DELETED**Second Revision No. 8186-NFPA 70-2021 [Detail]**

Committee: NEC-P18

Figure Figure Informational Note Figure 100.1 Clothes Closet Storage Space.

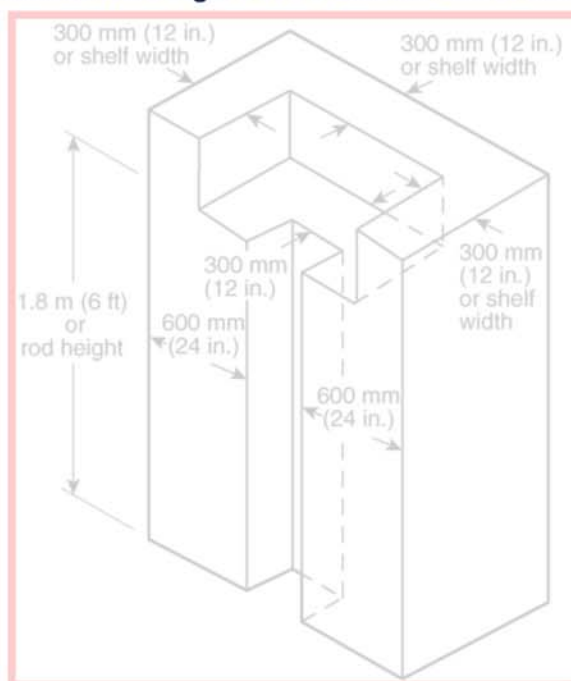
Committee Statement: The contents and figure are moved to 410.16 to comply with NEC Style Manual. The changes to the definition provide simplification and clarity.

Figure 410.16(A) Clothes Closet Storage Space.

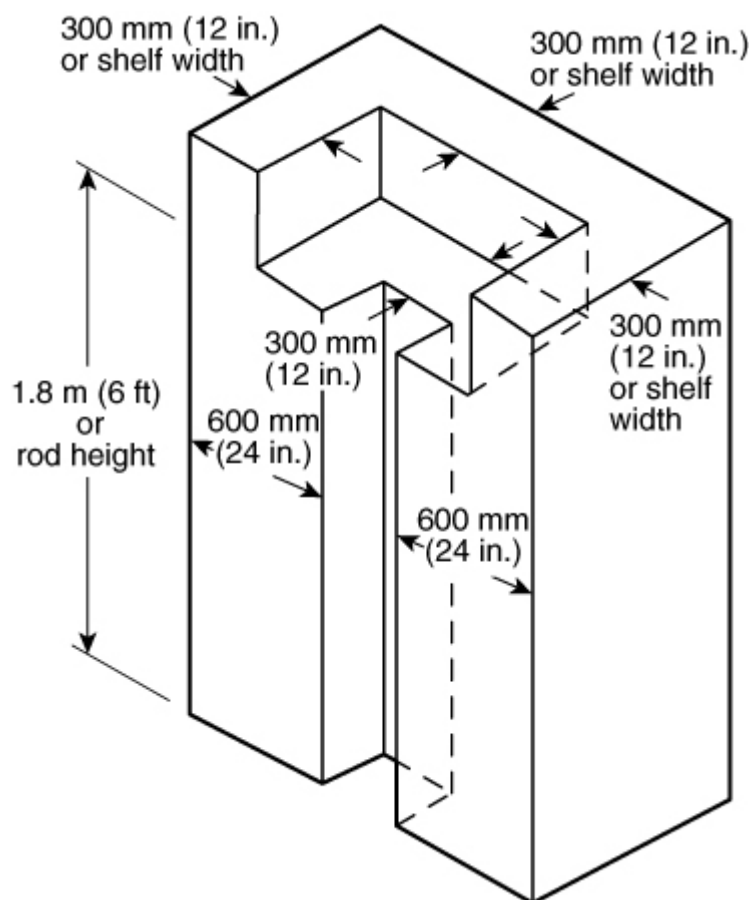
Committee Statement: The text and figure was relocated. This change will move the requirement that was embedded in the definition of "Clothes Closet Storage Space" to Article 410 to comply with 2.2.2.2 of the NEC Style Manual. The clause is restructured to provide clarity.

The clothes closet storage space shall be the volume bounded by the sides and back closet walls and planes extending from the closet floor vertically to a height of 1.8 m (6 ft) or to the highest clothes-hanging rod and parallel to the walls at a horizontal distance of 600 mm (24 in.) from the sides and back of the closet walls, respectively. The volume extends vertically to the closet ceiling parallel to the walls at a horizontal distance of 300 mm (12 in.) or the width of the shelf, whichever is greater. For a closet that permits access to both sides of a hanging rod, the clothes closet storage space includes the volume below the highest rod extending 300 mm (12 in.) on either side of the rod on a plane horizontal to the floor extending the entire length of the rod. See Figure 410.16(A).
